Bharat Heavy Electricals Ltd.,
BOILER PLANT UNIT
TIRUCHIRAPALLI-620 014

TITLE WIRE MESH TYPE - B (SCREEN TYPE DRIER ASSY)	CARD CODE U 01	DRAWING NO. 4-03-000-00002
--	-------------------	--------------------------------------

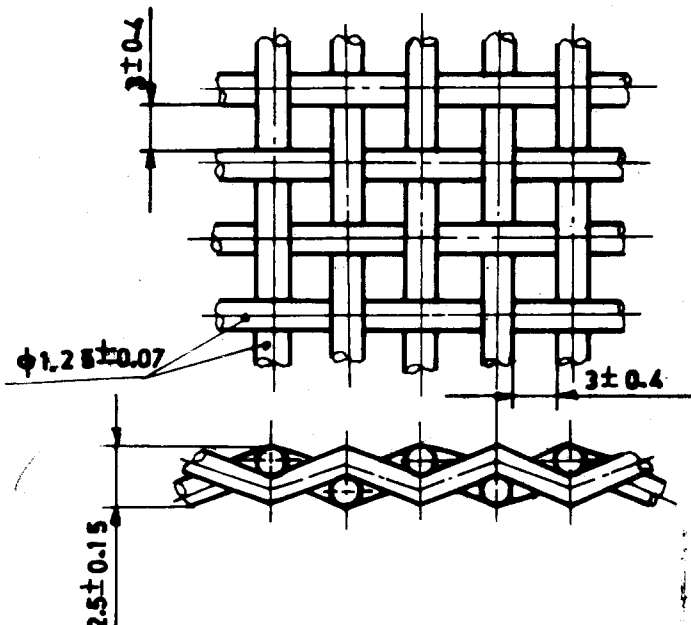
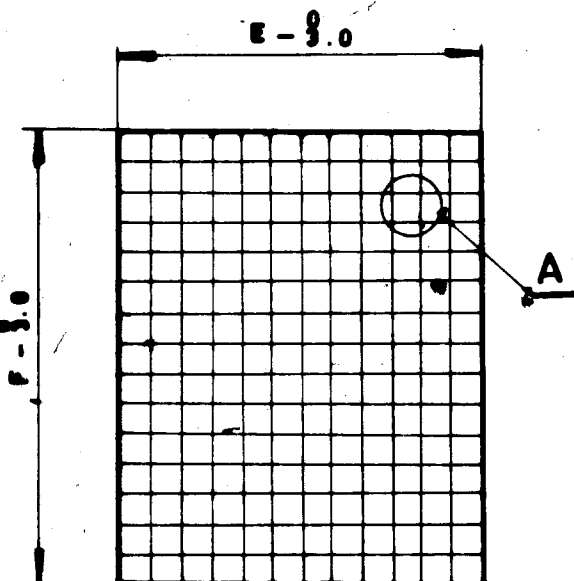
INSTEAD OF APERTURE SIZE 30MM, PITCH DIM WAS SHOWN AS 30MM. DRG UPDATED AND REFERENCES INCLUDED.

TOLERANCE IN WIRE DIA INCLUDED.
